INDESIT company

Model type:
MBA45D2NF

Commercial code:
F028560

0999342: Aluminium separator dimentions

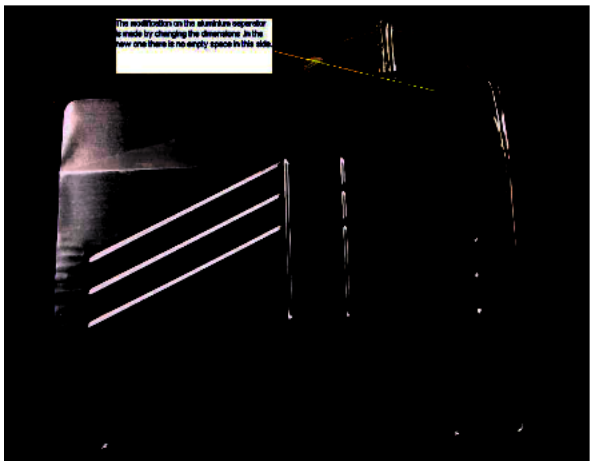
Modification on the aluminium separator is made by changing the dimentions. On the new one there is no empty space at the corner.Spare part code remain the same.

0999344: length of rezistance

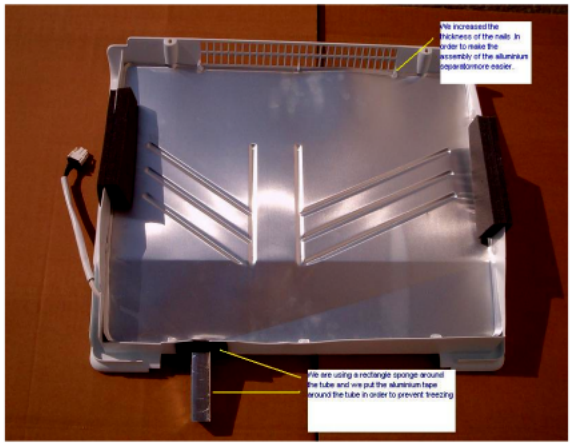
Length of rezistance which is placed on aluminium seperator has been increased.
